# Access Compliance Report

## Public Rights-of-Way

Intersection ID: 10025502	Main Street: E_MOREHEAD_ST	Cross Street: N/A	Location: SW
ADA ID: FECD623FF3C9	Ramp Type: BlendTrans1	Initial Pass/Fail: Fail	Overall Compliance: No
		Severity Score: 8.75

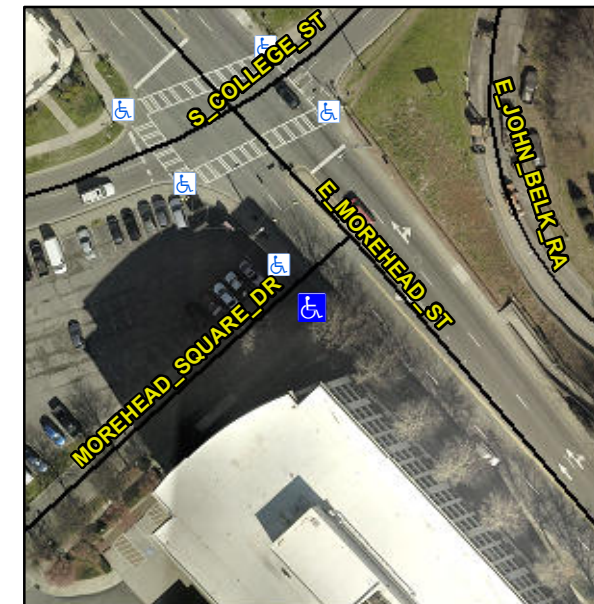
**Not Found, R304.5.1**

Compliance	Description	Data	Compliance	Description	Data
N/A	Ramp Length (in)	63.0	Yes	BlendTrans Slope (%)	2.7
No	Ramp Width (in)	36.0	Yes	BlendTrans XSlope (%)	0.7
N/A	Flare Type LT	N/A	N/A	Flare Type RT	N/A
N/A	Flare Slope LT (%)	N/A	N/A	Flare Slope RT (%)	N/A
N/A	Flare Traversable LT?	N/A	N/A	Flare Traversable RT?	N/A
N/A	Landing Length (in)	N/A	N/A	DWS Provided?	N/A
N/A	Landing Width (in)	N/A	N/A	DWS Contrast?	N/A
N/A	Landing Slope (%)	N/A	N/A	DWS Length (in)	N/A
N/A	Landing X Slope (%)	N/A	N/A	DWS Full Width?	N/A
N/A	Landing Curb? (Y/N)	N/A	N/A	DWS Offset (in)	N/A
N/A	Shared Landing?	N/A			
N/A	Gutter Ponding?	N/A	N/A	Gutter Slope (%)	N/A
N/A	Gutter Lip Ht (in)	N/A	N/A	Gutter X Slope (%)	N/A
N/A	Painted X Walk1?	No	N/A	Painted X Walk2?	No
	X Walk 1 Direction	To NE		X Walk 2 Direction	To NW
	X Walk 1 Width (in)	N/A		X Walk 2 Width (in)	N/A
	X Walk 1 Slope (%)	0.3		X Walk 2 Slope (%)	1.2
	X Walk 1 X Slope (%)	1.3		X Walk 2 X Slope (%)	2.5

N/A	Ramp inside XWalk1?	N/A	N/A	Ramp inside XWalk2?	N/A
	Road Slope (%)	2.7		Clear Space?	N/A
	Road X Slope (%)	3.0	N/A	Clear Space to XWalk (in)	N/A
N/A	Any Obstructions?	N/A	N/A	Storm Grate/Utility Hazard?	N/A
	Obstruction Type			Storm Grate/Utility Type	
		N/A			N/A
			Yes	Surface Condition? (G/P)	Good
			No	Curb Slope (%)	22.3

**Remove & Replace Curb Ramp With Two New Directional Ramps or Equivalent.**
